No.RT-11028/01/2018-MVL
Government of India
Ministry of Road Transport &Highways
(MVL Section)
Transport Bhawan, 1, Parliament Street, New Delhi-110001

**Subject : Amendment in CMVR, 1989 for High Security Registration Plates
and proposed draft order.**

The MOTOR VEHICLES (NEW HIGH SECURITY REGISTRATION PLATES) ORDER, 2018

उपाबन्ध

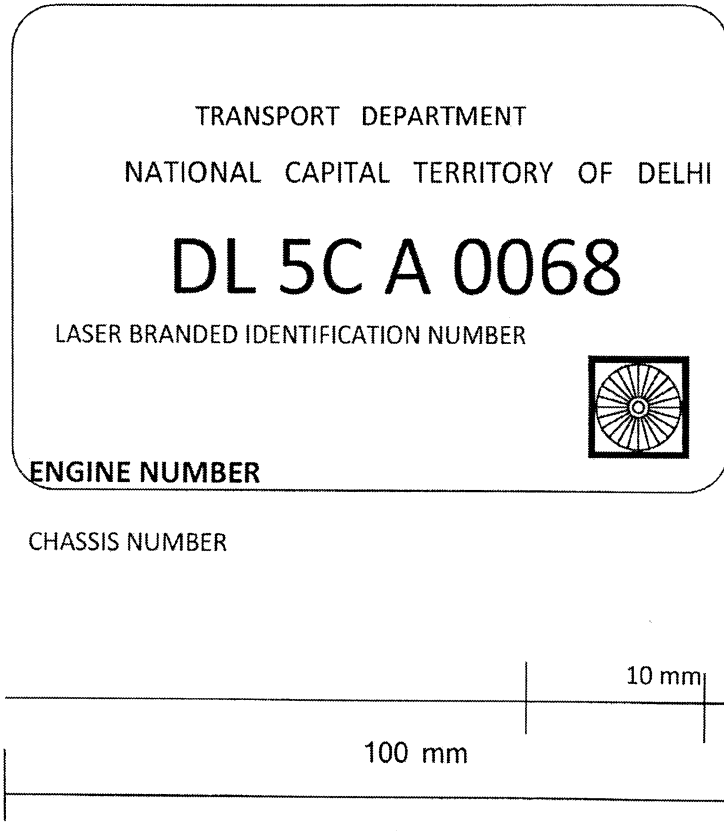
- (v) कूट रचना से संरक्षण के लिए 20 मिलीमीटर X 20 मिलीमीटर आकार का एक क्रोमियम आधारित होलोग्राम प्लेट के शीर्षस्थ बाईं ओर के कोने पर सामने और पीछे दोनों प्लेटों पर ताप स्टॉपन द्वारा लगाया जाना है। होलोग्राम में इस आदेश से संलग्न उपाबंध के अनुसार नीले रंग का चक्र बना होगा।

- (viii) स्व-विध्वंशकारी प्रकार की क्रोमियम आधारित होलोग्राम स्टिकर के प्ररूप में तृतीय रजिस्ट्रीकरण प्लेट 100 मिमी0 X 50 मिमी0 के आकार की होगी, वाहन के वायु रोधी के बायें हाथ के किनारे के अंदर की तरफ चस्पा की जानी है। स्टिकर पर (क) रजिस्ट्रीकरण प्राधिकारी का नाम, (ख)वाहन की रजिस्ट्रीकरण संख्यांक (ग)लेजर ब्रांड की स्थायी पहचान संख्यांक (घ) इंजन संख्यांक, और (ङ) यान की चेसिस संख्यांक के ब्योरे होंगे। स्टिकर के दायें कोनों के तल पर नीचे क्रोमियम आधारित होलोग्राम लगाया जायेगा किन्तु 10 मिमी0 X 10मिमी0 के लघु आकार का होगा। उक्त स्टिकर में यान का रजिस्ट्रीकरण संख्यांकके केन्द्र में होगा और अक्षरों की ऊँचाई 10 मिमी0 होगी। लेजर ब्राण्ड वाला स्थायी पहचान संख्यांक, इंजन संख्यांक और चेसिस संख्यांक प्रत्येक मामलें में 2.5 मिमी0 आकार के अंको के साथ स्टिकर के तल में बाँयी ओर आयेगें। स्टिकर का चित्र इस आदेश से संलग्न उपाबन्ध मे विनिर्दिष्ट रेखाचित्र में दिया गया है। स्टिकर की फिल्म अनिवार्यतः उच्च परावर्ती अभिसूचक सहित डिफ्रेक्शन फॉयल की होनी चाहिए और उसमें क्रोमियम आधारित होलोग्राम जुड़ा हुआ होगा।

- (v) To protect against counterfeiting, a chromium-based hologram of the size 20 mm x 20 mm is to be applied by hot stamping on the top left-hand corner of the plate in both front and rear plates. The hologram shall contain CHAKRA in blue colour as given in the Annexure enclosed with this Order.

- (viii) The third registration plate, in the form of a self-destructive type chromium based hologram sticker shall be of the size of 100 mm x 50 mm, is to be affixed on the inner side of left hand corner of windshield of the vehicle. The details on the sticker shall be (a) name of registering authority, (b) registration number of the vehicle, (c) laser branded permanent identification number, (d) engine number, and (e) chassis number of the vehicle. On the bottom of the right corner of the sticker, the chromium based hologram shall be applied but of a smaller size of 10 mm x10 mm. The registration number of the vehicle shall be in the centre with a letter size of 10 mm in height in the said sticker. The laser branded permanent identification number, followed by the engine number and the chassis

number, shall come in the bottom left side of the sticker with numeral size being 2.5 mm in each case. A depiction of the sticker is given in the sketch as specified in the Annexure annexed to this Order. The sticker should essentially be a diffraction foil film with high reflective index and shall have the chromium based hologram embedded.
